Two Rivers - Second adequacy review

**Re: Two Rivers Sand, Gravel and Reservoir Project, File No. M-2022-013,
112c Permit Application, Second Adequacy Review**

**Subject: Two Rivers Sand, Gravel and Reservoir Project (Permit No. M-2022-013)
Application**

Figure 1: Screenshot of portion of Exhibit G: Water Information Map @ 300% zoom

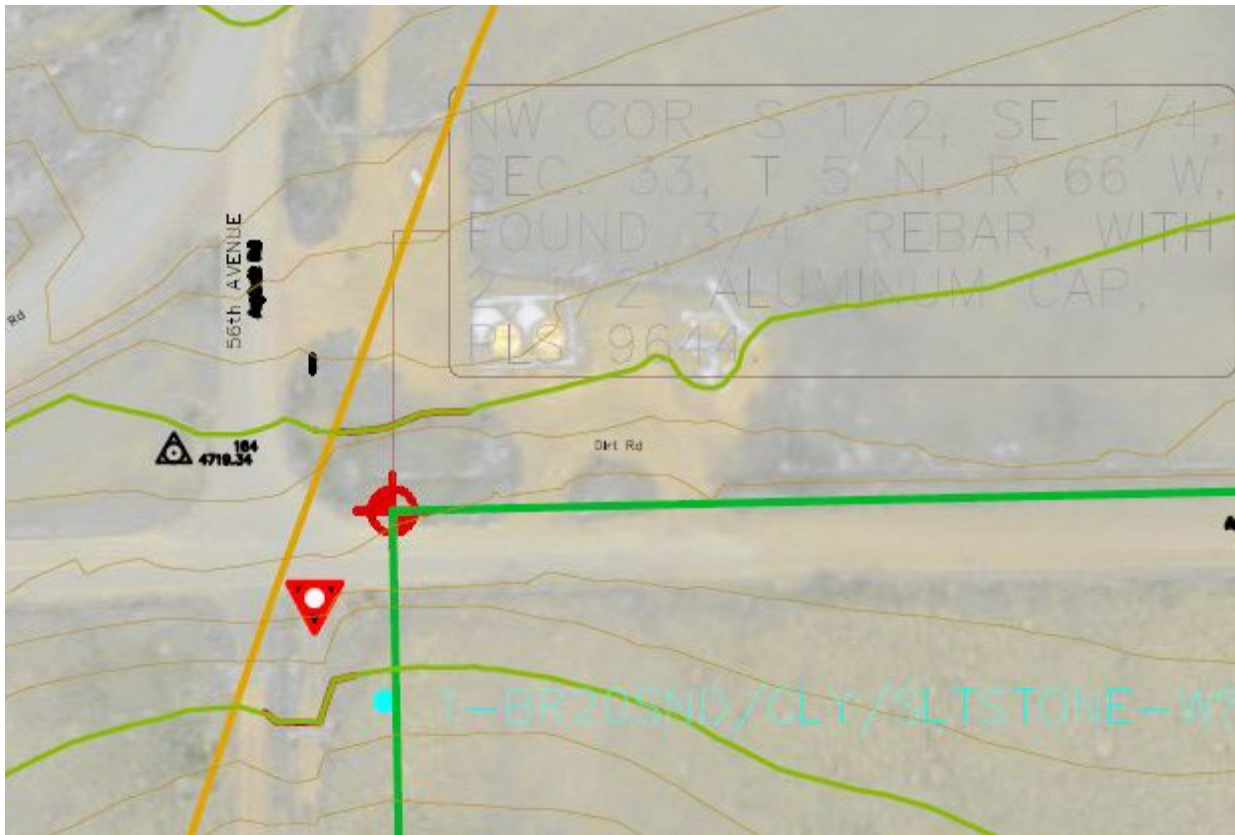
3. *Water level data from piezometers P124-1 through P124-12 has been given in the text of Exhibit G but the locations of the piezometers are not shown on Exhibit G: Water Information Map (or Exhibit C-1: Existing Conditions Map).
Please add the piezometer locations to Exhibit G: Water Information Map*

Piezometer locations have been shown on the updated version of Exhibit G: Water Information Map, however they are labelled using a different naming convention (see figure 1). Please label the piezometers on the map as they are referred to in the text of the AWES study.

- Inverted red triangles (as shown in figure 1)
- Bold red lines and squares (as shown in figure 2)
- Yellow highlighting on contour lines (as shown in figure 2)

Figure 2: Screenshot of portion of Exhibit G: Water Information Map @ 300% zoom

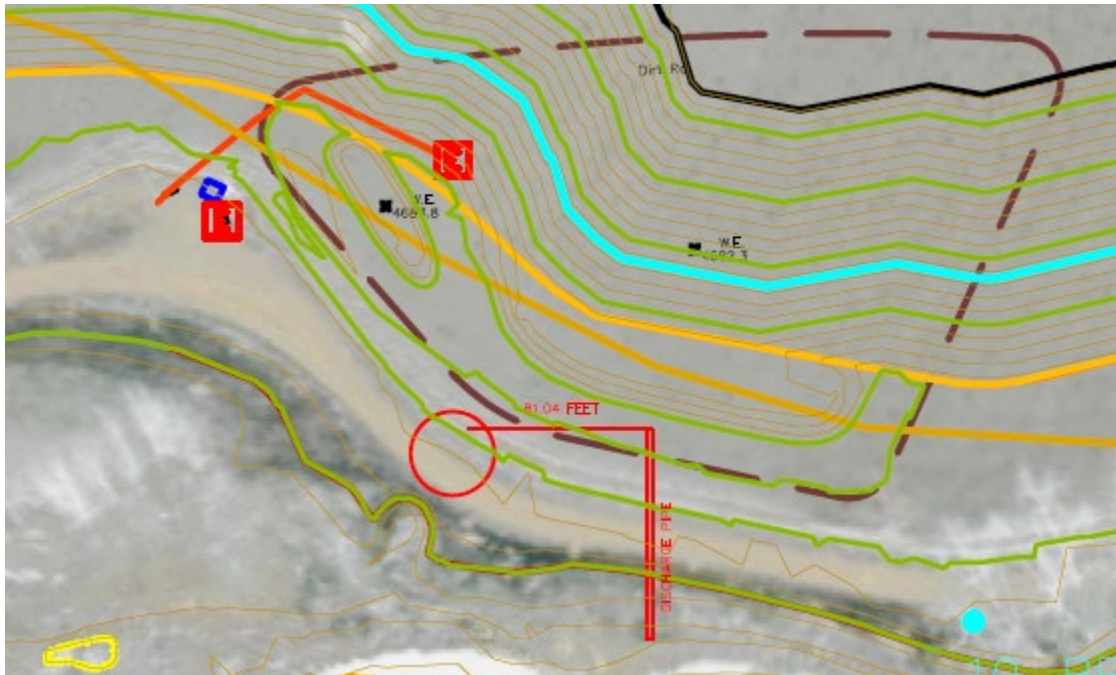
- Dashed brown line (as shown in figure 2)
- Yellow polygons (as shown in figure 3)
- Blue marks (as shown in figure 3)
- Fine dashed red lines (as shown in figure 3)
- Light red dots (as shown in figure 3)
- Black triangles (as shown in figure 3)
